Integrus Architecture, P.S.
117 S Main Street
Seattle, WA 98104
(206) 628-3137

The additions, clarifications and corrections contained herein shall be made to the Project Manual, Drawings and Schedules for the above referenced project, and shall be included in the scope of work and proposal to be submitted.

Sartori Elementary School

DWG. # **ADC-024**
 JOB # 21607.00
 DRAWN BY: FAK
 DATE: 03/17/17
 REF. DOC.: ADDENDUM #1

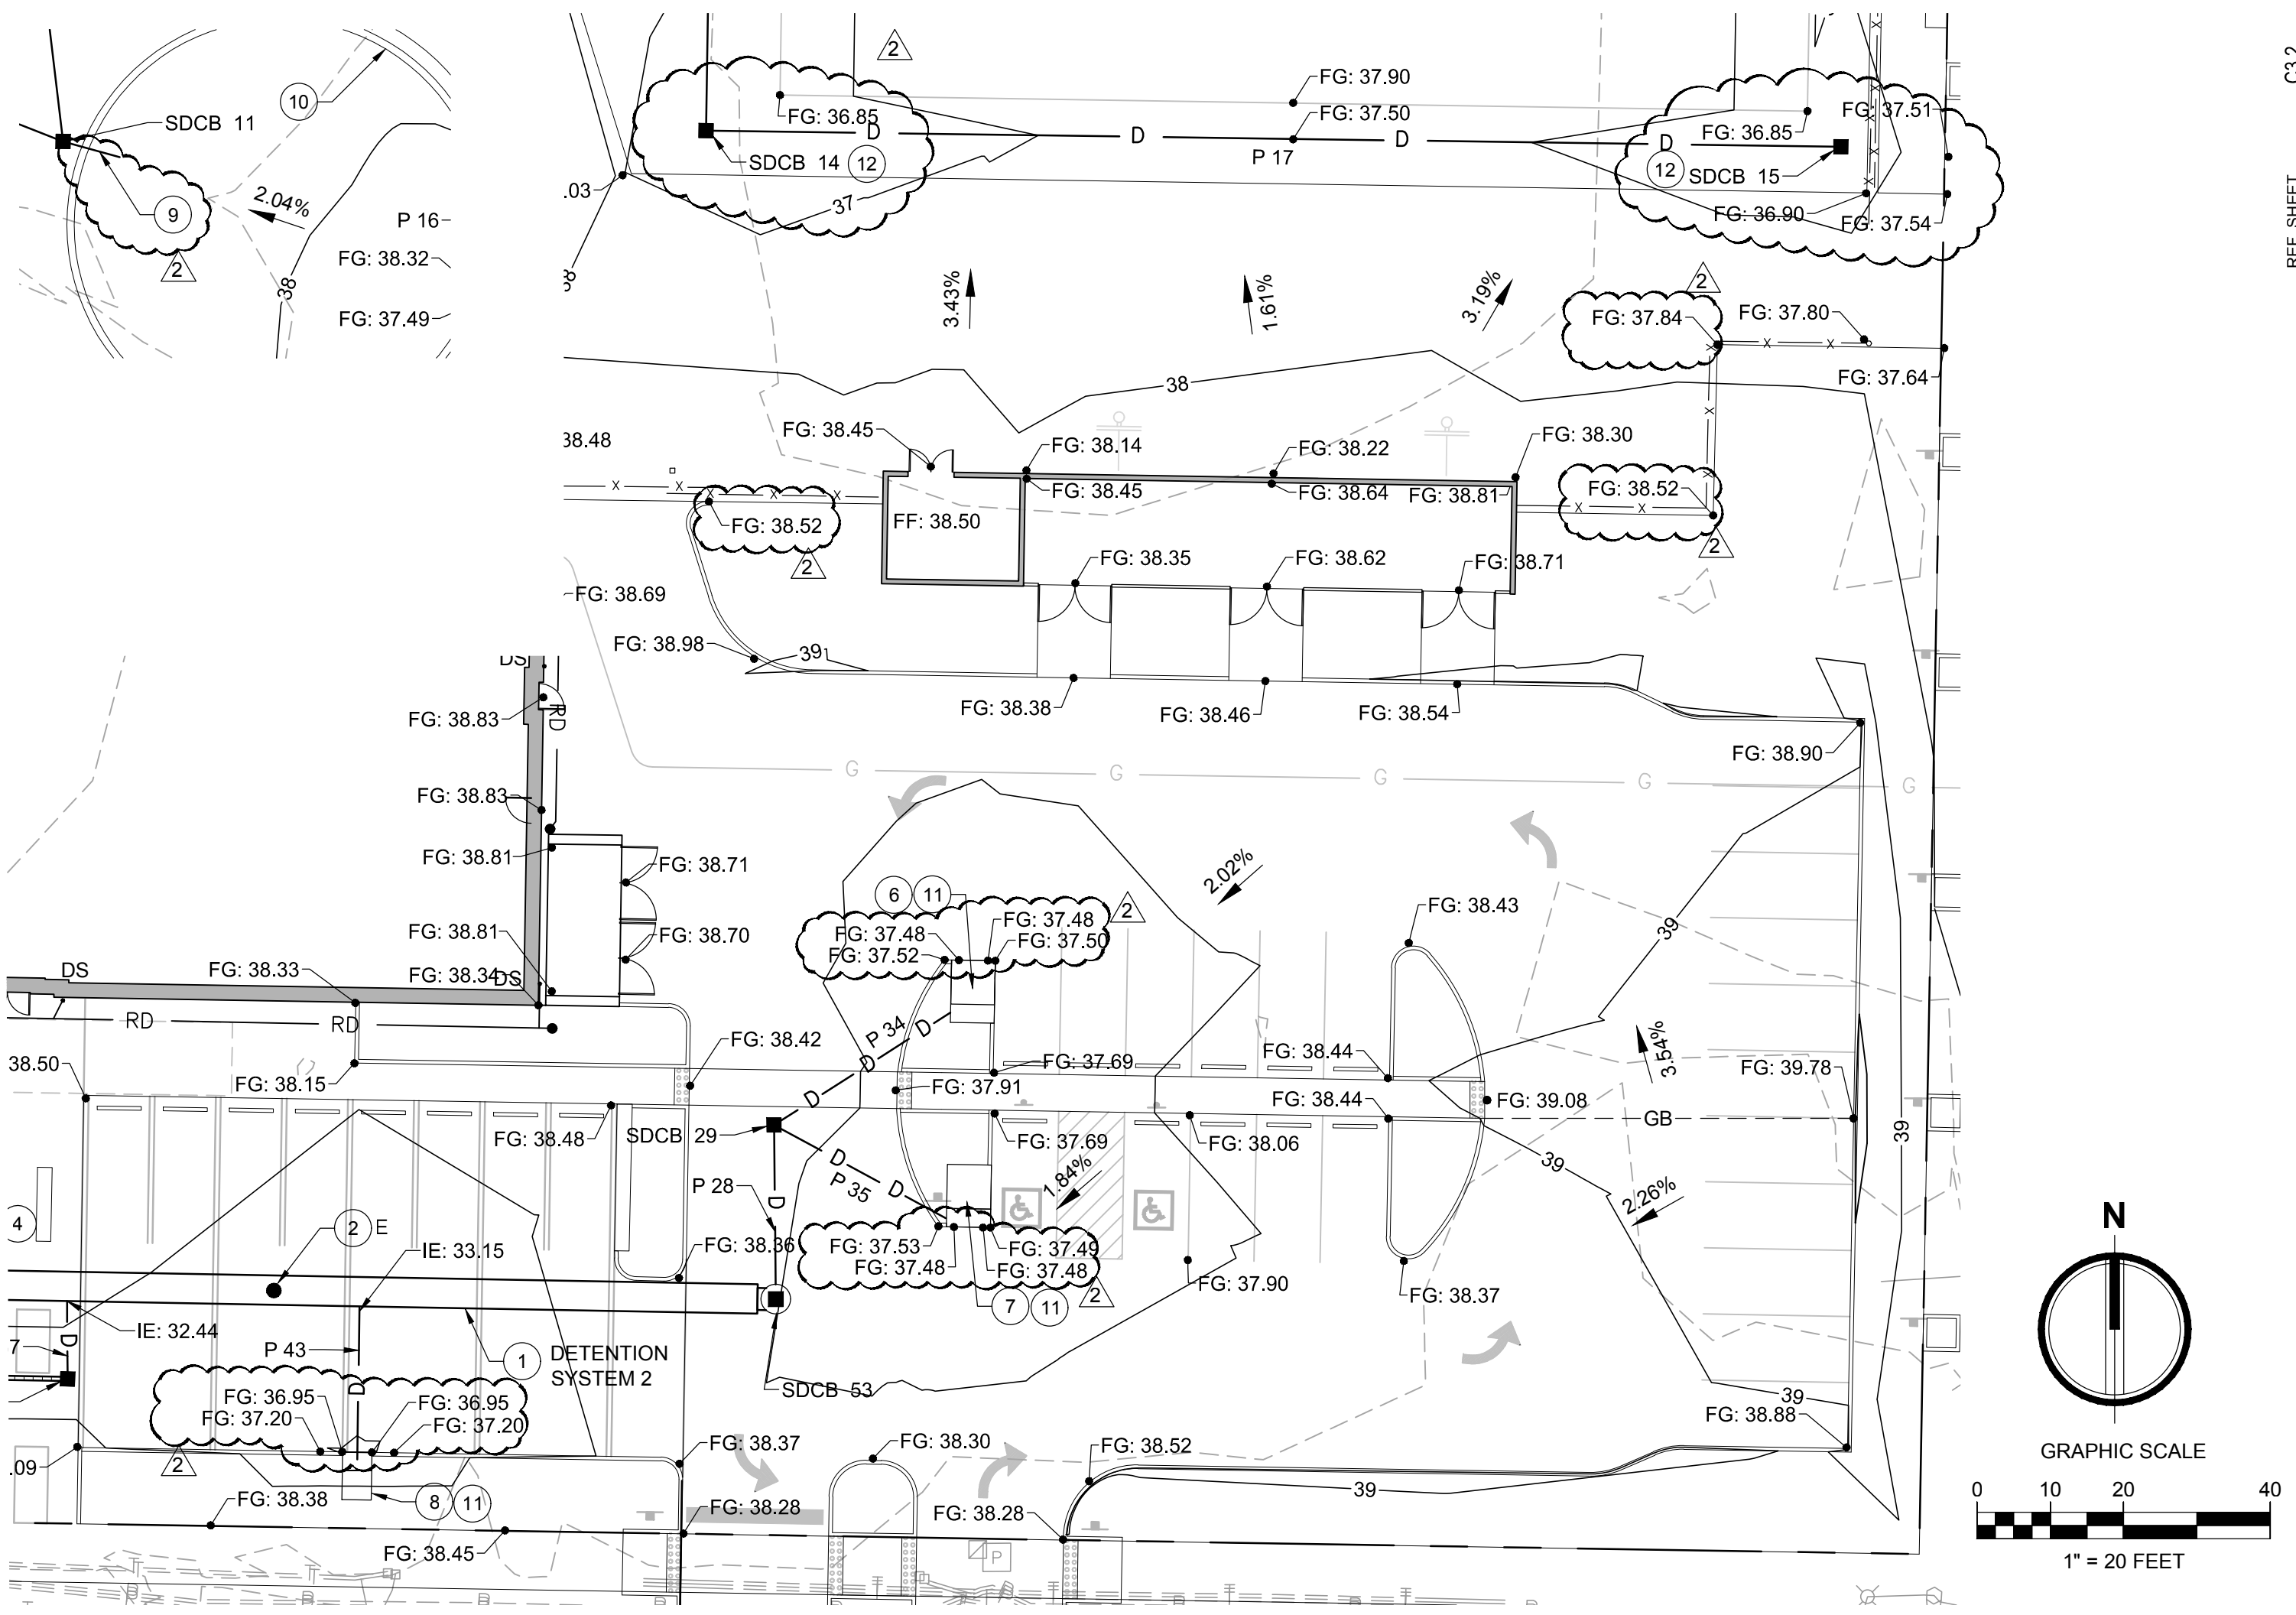
- Item #C06 C3.1 – NORTH GRADING AND DRAINAGE PLAN
ADD #03 **Revise** sheet per ADC 24, ADC 25, and ADC 28.
- Item #C07 C3.2 – SOUTH GRADING AND DRAINAGE PLAN
ADD #03 **Revise** sheet per ADC 26, ADC 27, and ADC 29.

DATE: 02/22/2017
FIELDBOOK:
PAGE:
DRAWING NO.: C6.9
SHEET: 29 OF 43

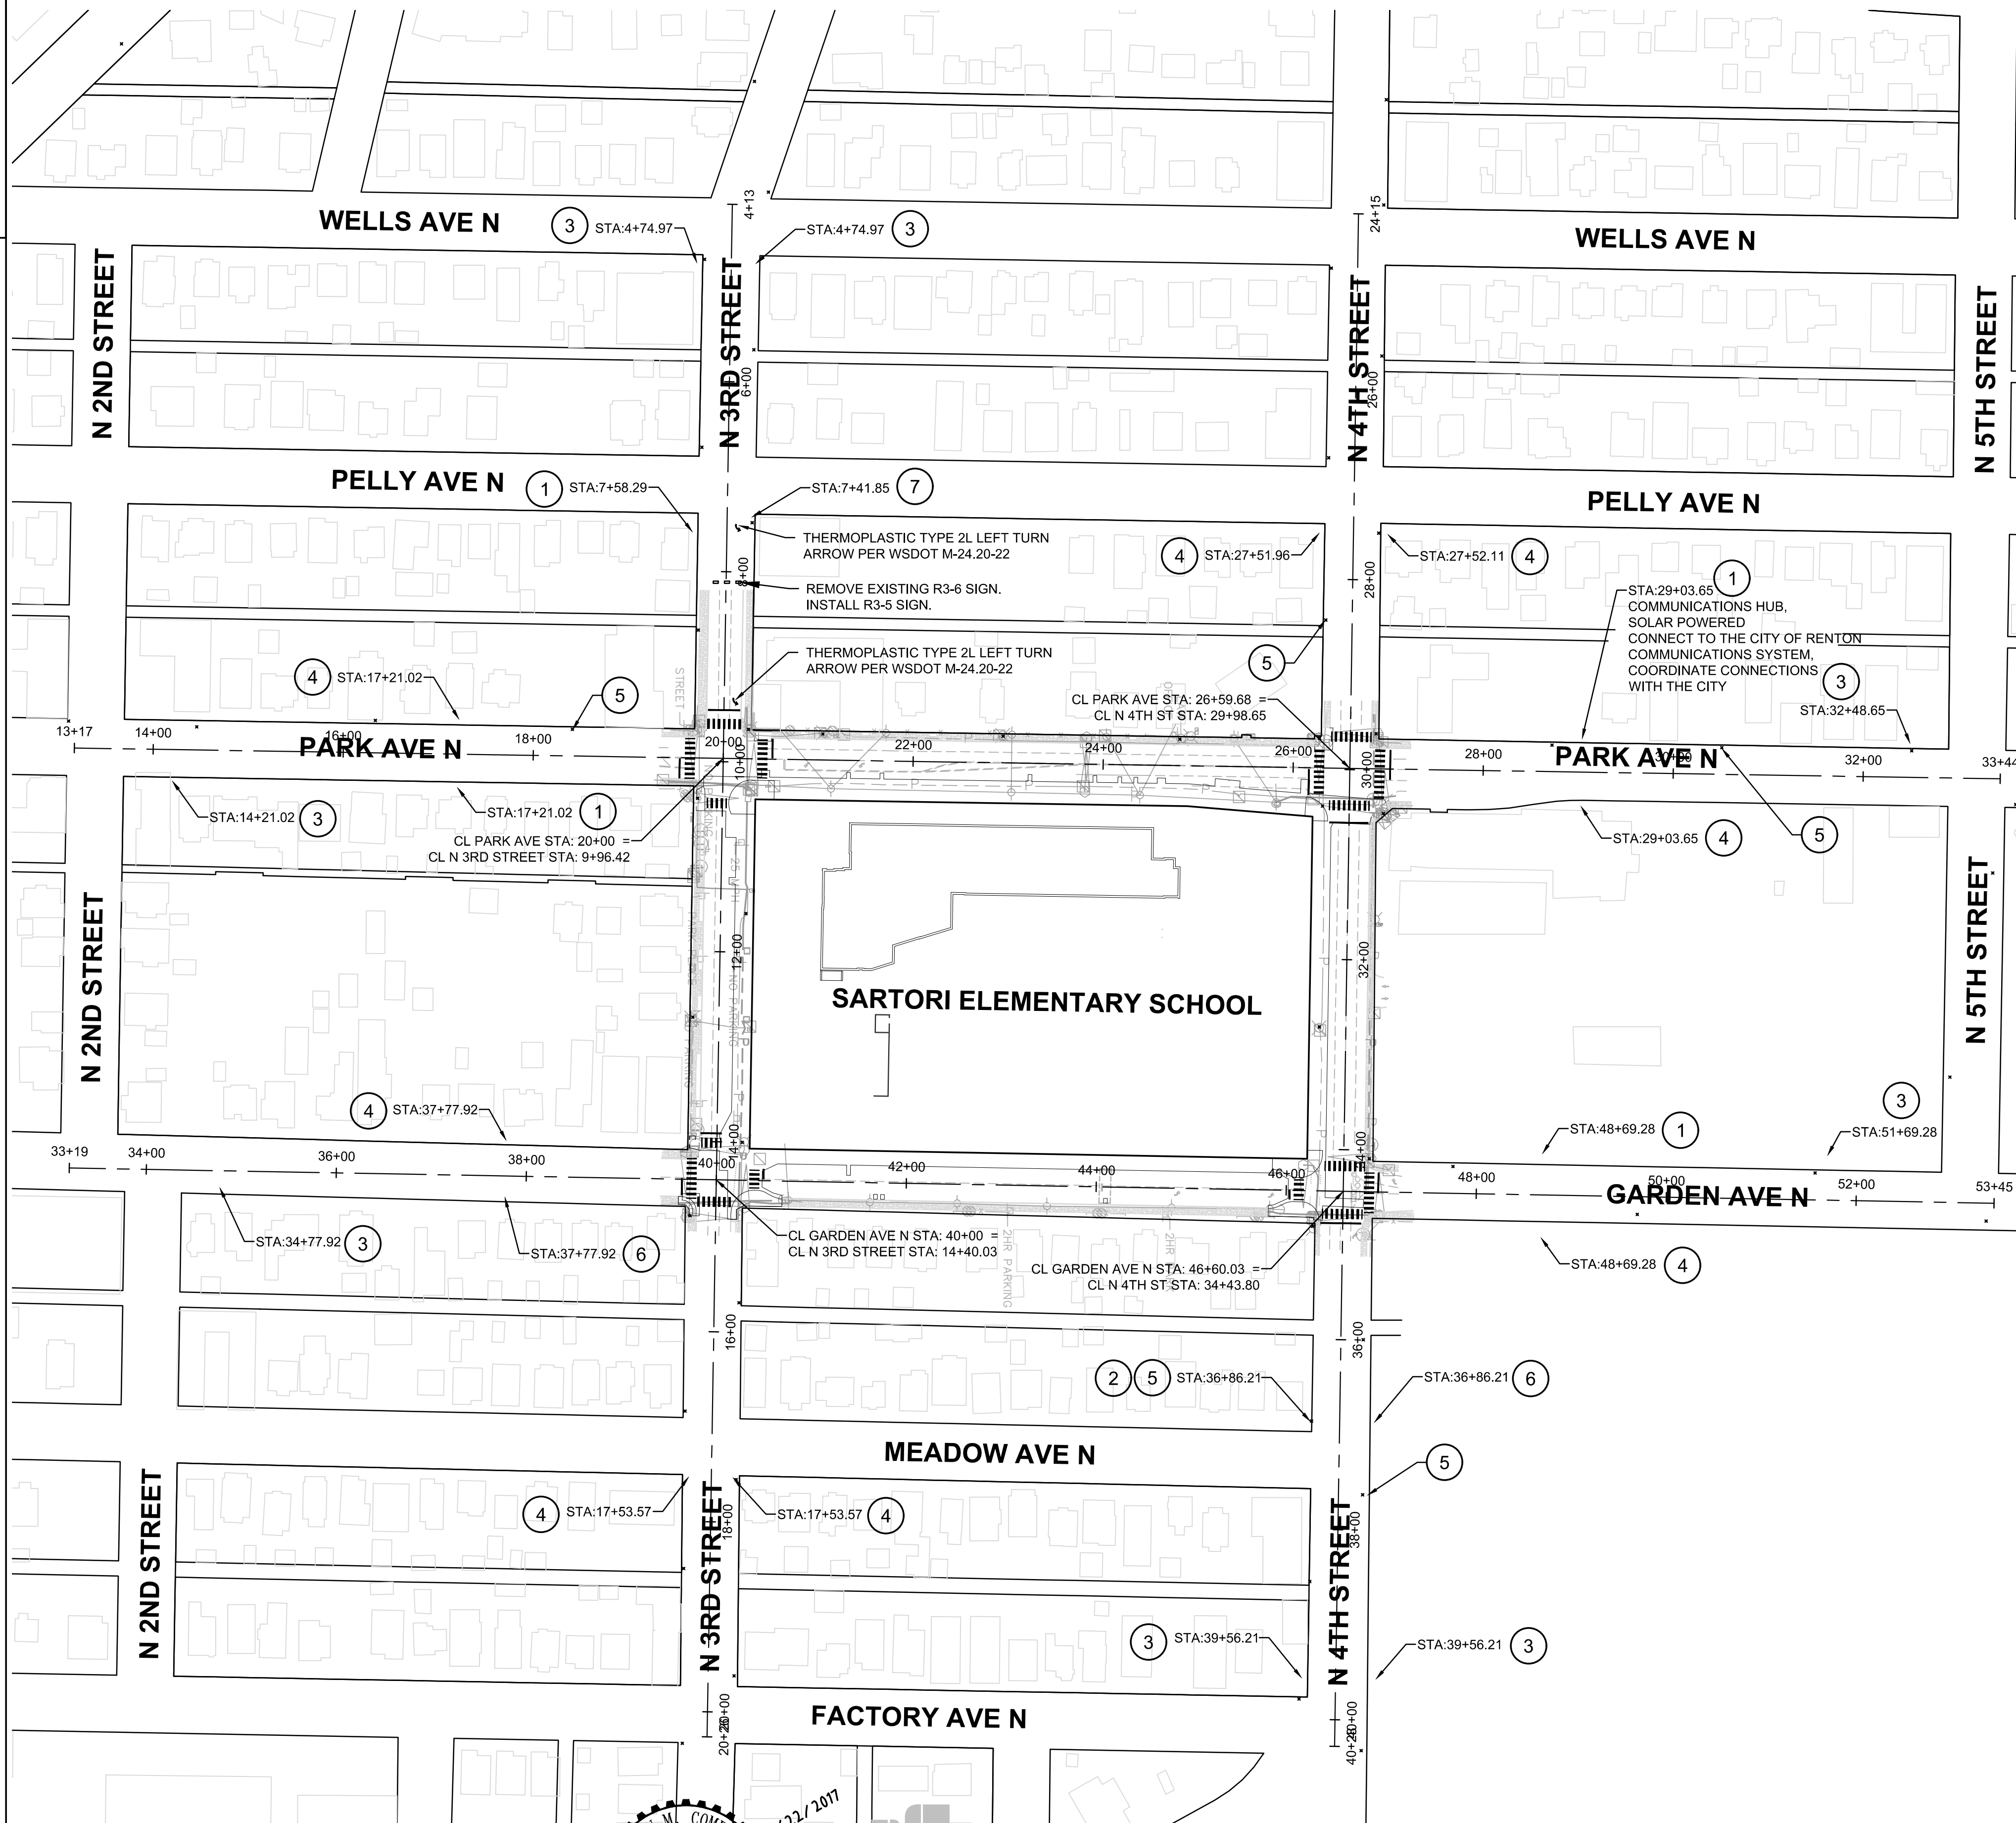
Item #C23 C6.9 – OFF-SITE SIGNAGE PLAN
ADD #03 **Replace** the sheet with the attached Sheet C6.9. The sheet **adds** offsite signage and speed beacon and radar detection system.

DWG. #: **ADA-075**
 JOB #: 21607.00
 DRAWN BY: BT
 DATE: 03/17/17
 REF. DOC.: ADDENDUM #3

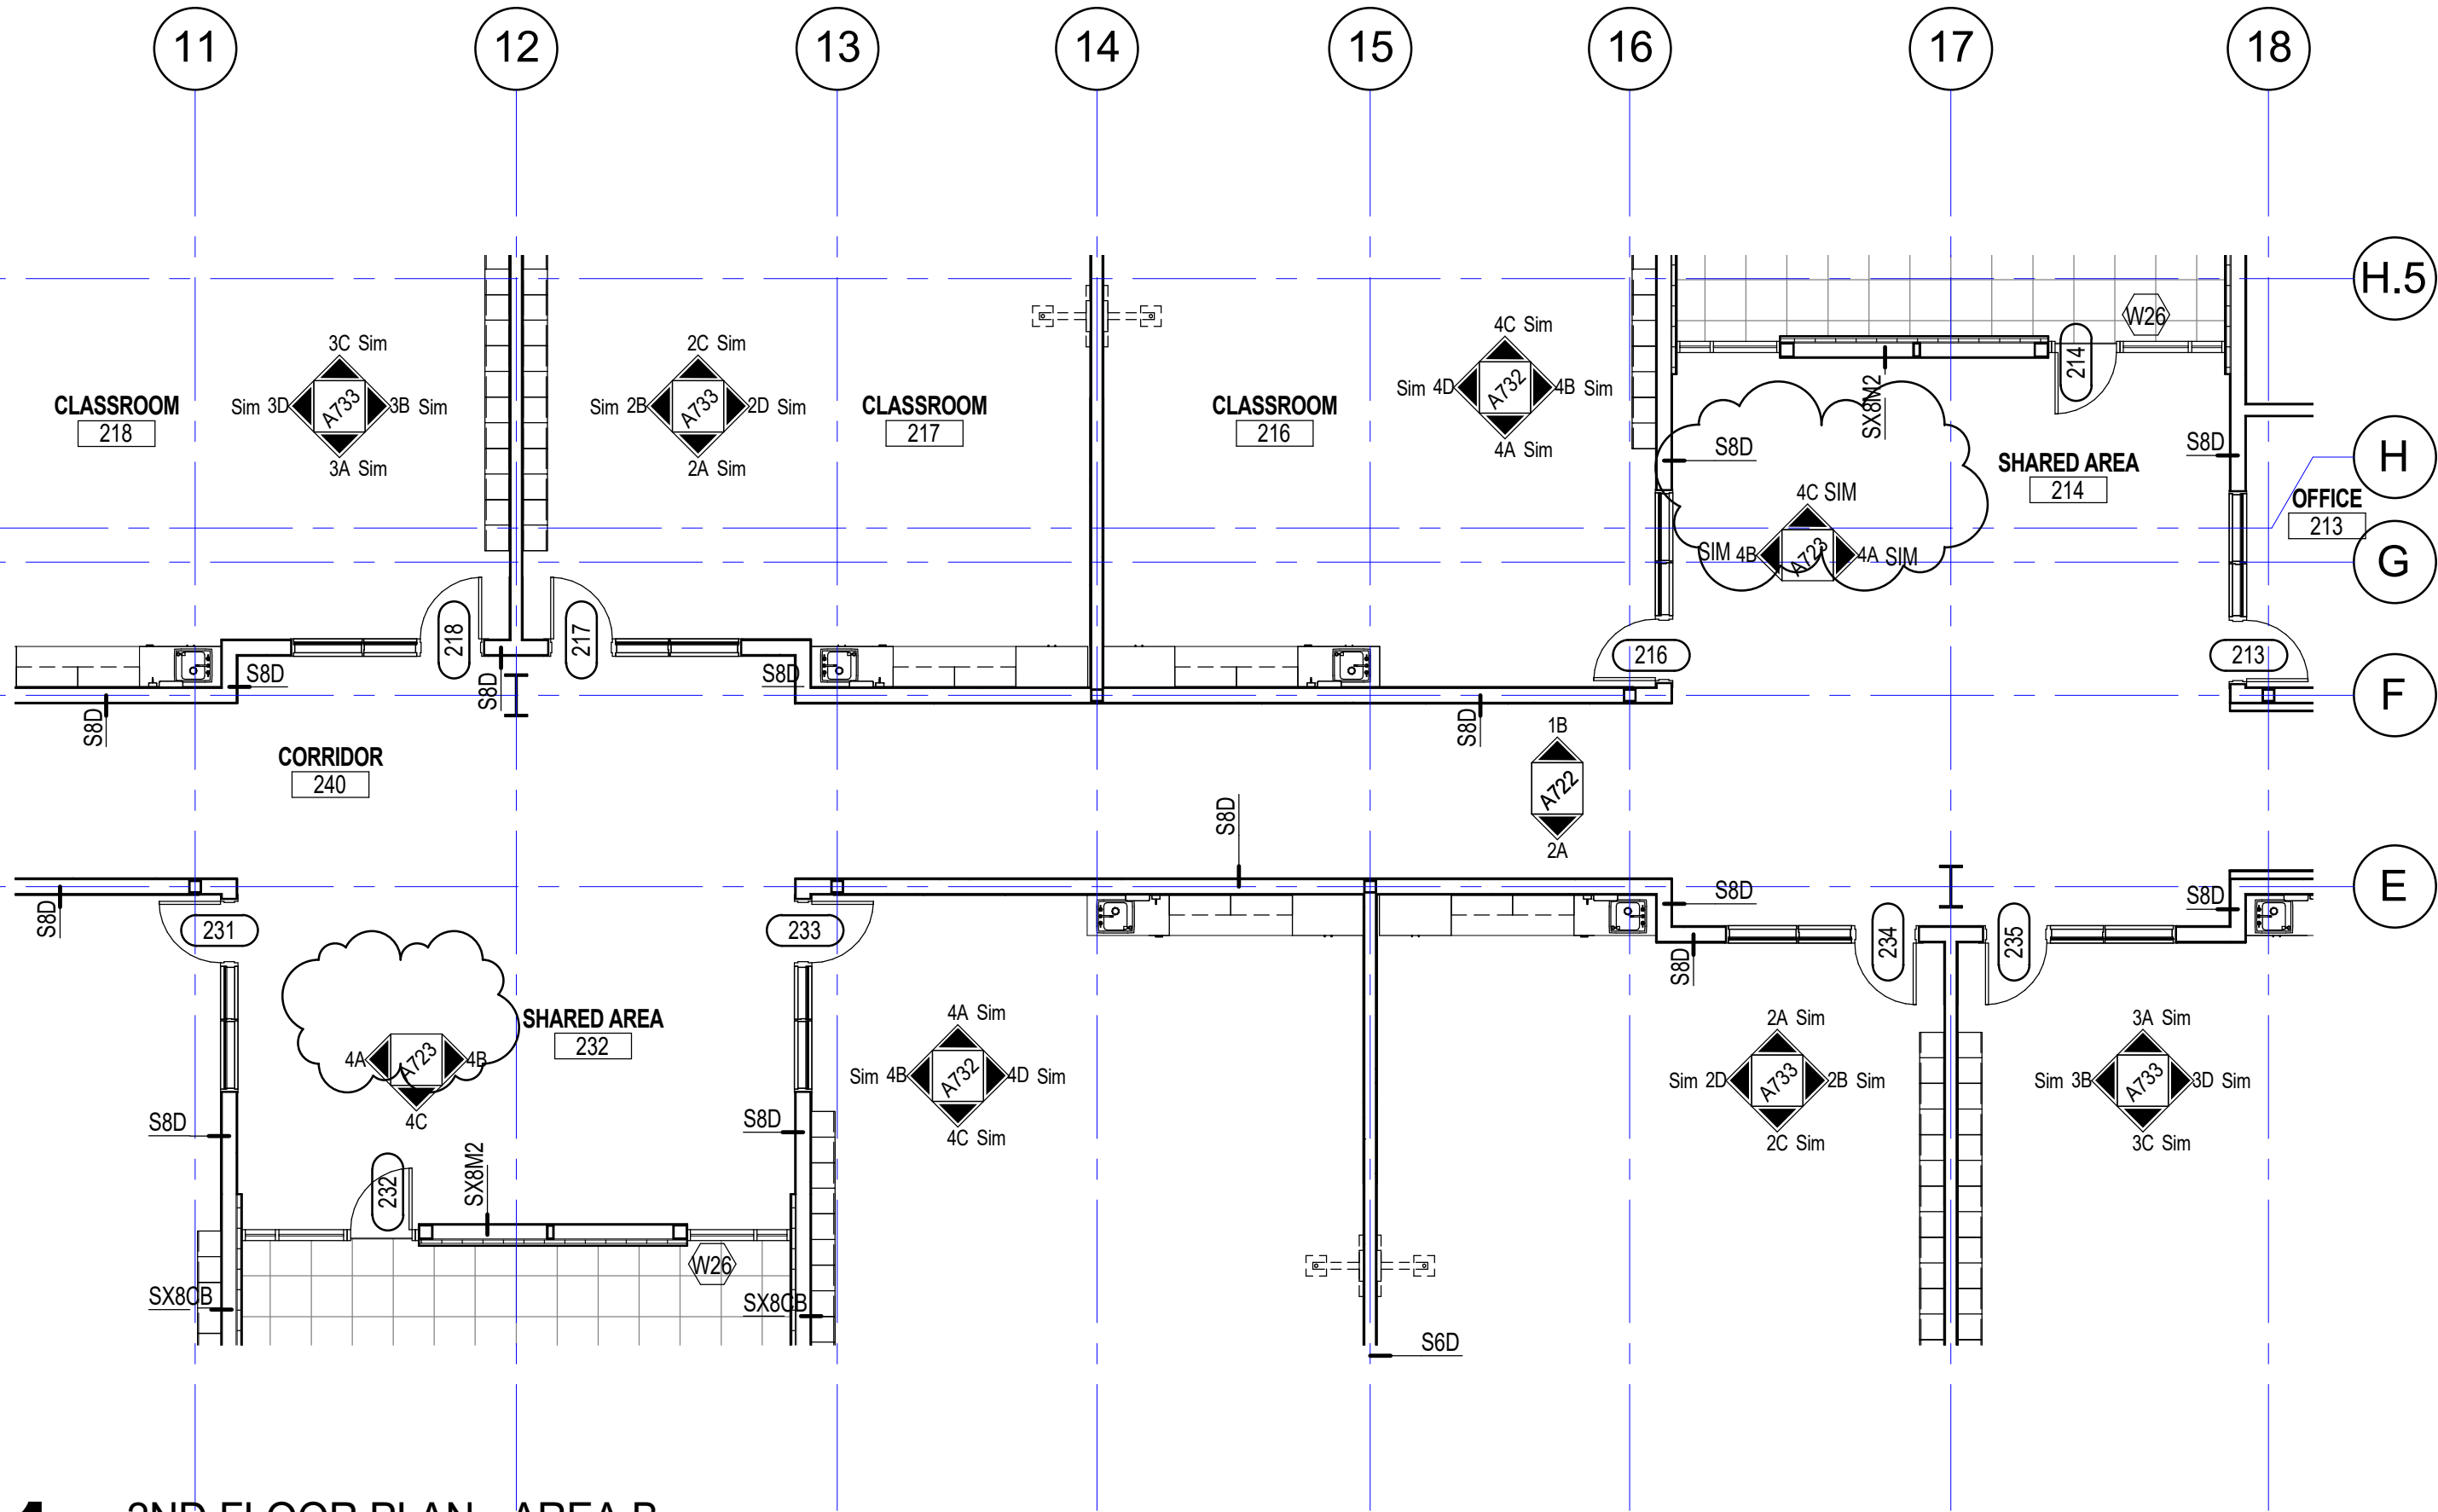
- Item #A02 A101B - DIM – 1ST FLOOR DIMENSION PLAN AREA B
ADD #03 **Revise** framing dimensions per attached ADA-074.
- Item #A03 A102B – 2ND FLOOR PLAN AREA B
ADD #03 **Add** Interior elevation tags at SHARED AREA 214 and SHARED AREA 232 per attached sketch ADA-075.
